***DA 2024/1562 – 5 Lauderdale Avenue, Fairlight NSW 2094 – Objection by SP 45435 and by Owners***

## **VISUAL IMPACT ASSESSMENT**

**OBJECTION to Development Application DA2024/1562 at**

**DP 24923, No.5, Lauderdale Avenue, Fairlight.**

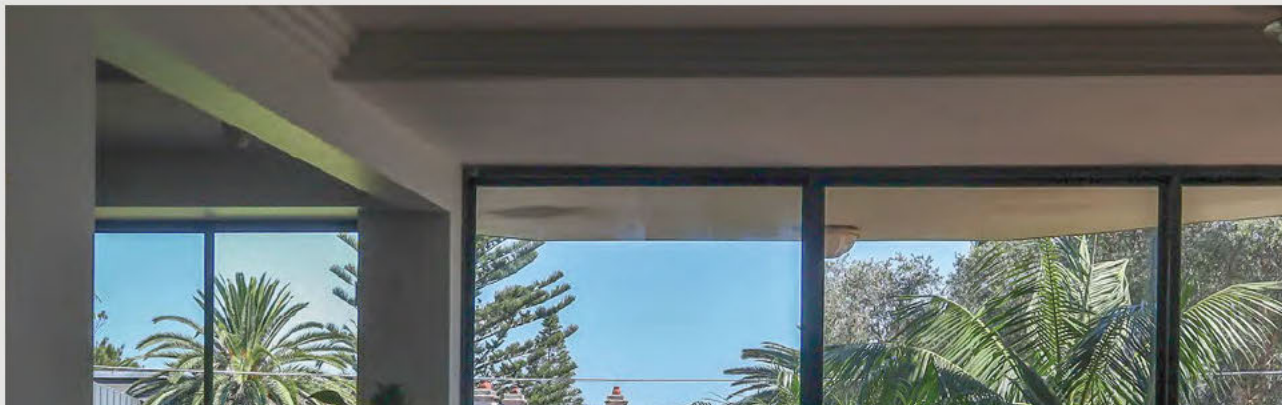
This is a static, private view from the ground floor balcony of unit 1, No.8 Lauderdale Avenue, 1m from the balustrade at standing height, and looking south west to the subject site.

The impact of the proposal will result in both central view loss of water, mid-ground land water interface and far distance view. The view gain is primarily to sky with mid ground gain along the boundary, though as planting matures the view corridor would likely reduce. The visual impact is the increase in bulk and scale and the removal of softer, landscape elements that filter the view.
